**City of Glendale
Community Development Department
Design Review Staff Report – Multi-Family**

Meeting/Decision Date: June 8, 2020	Address: 737 South Adams Street
Review Authority: <input type="checkbox"/> DRB <input checked="" type="checkbox"/> ADR <input type="checkbox"/> HPC <input type="checkbox"/> CC	APN: 5675-019-003
Case Number: PDR1924574	Applicant: Jesus Valdiviezo
Prepared By: Danny Manasserian, Planning Associate	Owner: Jesus Valdiviezo

The applicant is proposing to construct a new 1,101 SF, two-story, residential unit with an attached 440 SF two-car garage at the rear of a 7,500 SF lot. The existing property contains a 1,644 SF house with an attached three-car garage. The property is located in the R-2250 (Medium Density Residential) zone.

SITE PLAN

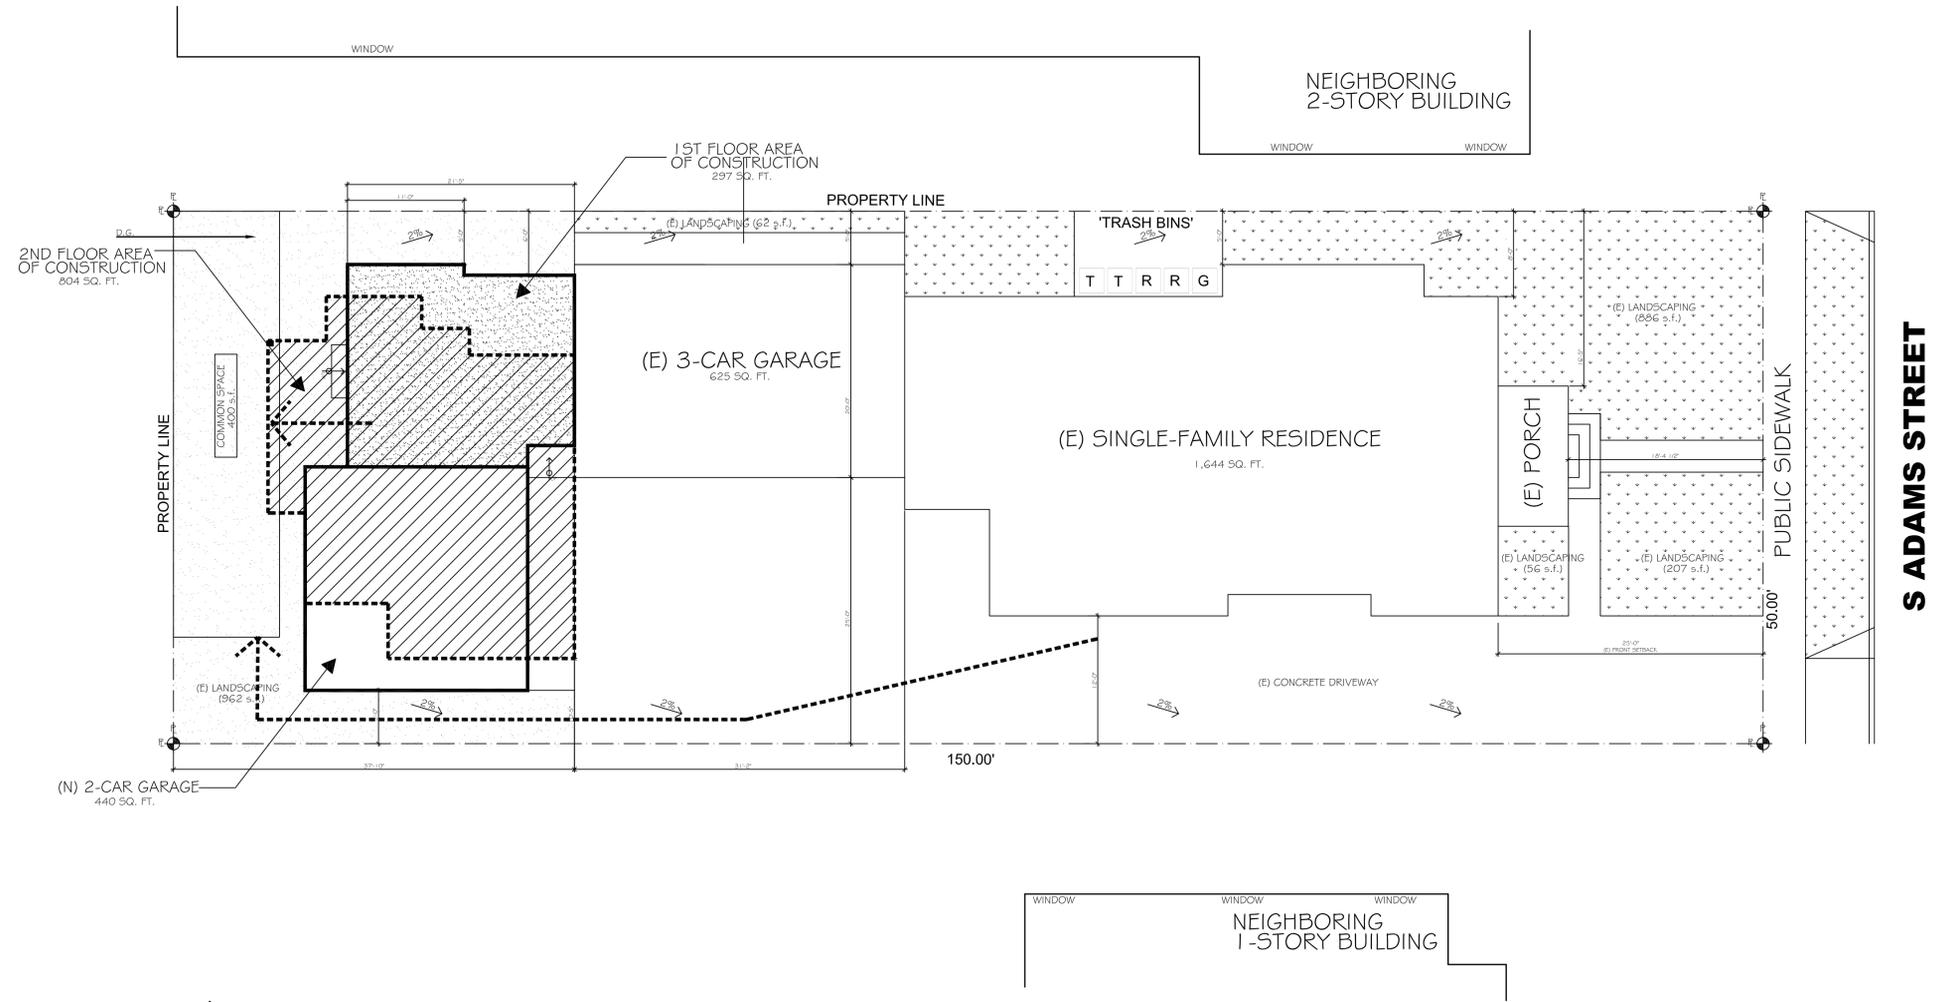
Applicant shall submit a detailed landscape plan showing perimeter drought tolerant plants, trees, and permeable pavers in development of the landscape area around the new second unit prior to final approval.

Overall the lighting plan is acceptable however one light fixture should be removed at the second floor balcony to avoid over-lighting. Also, the flood light fixture shall be replaced with a shielded fixture or the fixture used throughout the project.

1. Applicant shall submit a detailed landscape plan, showing perimeter drought tolerant plants and trees. Permeable pavers shall be used at paved areas in development of the landscape area around the new second unit for staff review and applicant shall submit a sample for approval.
2. Overall the lighting plan is acceptable however one light fixture should be removed at the second floor balcony to avoid over-lighting. Also, the flood light fixture shall be replaced with a shielded fixture or the fixture used throughout the project.
